## ARM940T Rev.2v2 Errata ListARM940T Rev.2v2 Errata List

Document number: ARM940T-PRDC-000610 2.0  
Date of Issue: 17<sup>th</sup> December 2001  
Author: Paul Garden  
Authorized by: Jason Ackroyd

This document describes the known errata in the ARM940T Rev 2 v2 design.

### 4.1 Boundary Scan Cell Enable Transition During JTAG Reset (ARM9TDMI – 4)

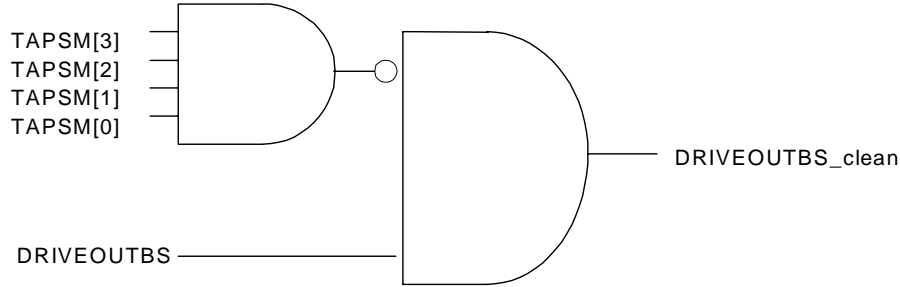
If the TAP controller state machine is made to enter the reset state by holding TMS high whilst its current instruction is INTEST, EXTEST, CLAMPZ or CLAMP then DRIVEOUTBS will be asserted for one TCK cycle. If the reset mechanism is nTRST then DRIVEOUTBS is driven correctly.

However during debug operation the TAP controller may be reset independently of a system reset. In this case, if TMS is used as the mechanism for causing the TAP controller to enter the reset state then DRIVEOUTBS will be incorrectly asserted. When DRIVEOUTBS is asserted the external scan chains will select the scan path and this could cause incorrect operation of the device.

The following external logic should be added to ensure correct operation of DRIVEOUTBS.

`DRIVEOUTBS_clean = (TAPSM != 4'b1111) & DRIVEOUTBS`

## 4.2 Coprocessor Memory Transfer incorrectly marked as being sequential (ARM9TDMI – 5)

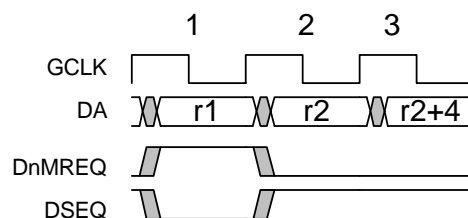
A coprocessor memory transfer instruction (LDC or STC) can incorrectly have its first access (a non-sequential access) marked as being sequential.

During cycle (1) in the diagram above, the DnMREQ is high and DSEQ is low, indicating an IDLE cycle. This corresponds to the IDLE cycle generated by the LDC which fails its condition code check. In cycle (2) the first memory transfer for the second LDC occurs. In cycle DSEQ is incorrectly high, marking the transfer as being sequential.

If a coprocessor is attached with can execute LDC or STC instructions then this errata only applies if the coprocessor can execute an LDC or STC without busy-waiting the processor first. Thus a hardware workaround is to ensure all attached coprocessors insert a busy wait cycle before executing a LDC or STC.

A second work around is to ensure that the code does not contain a sequential instruction pair of LDC or STC instructions where it is possible for the first instruction to fail its condition code check and for the second to pass its condition code check.
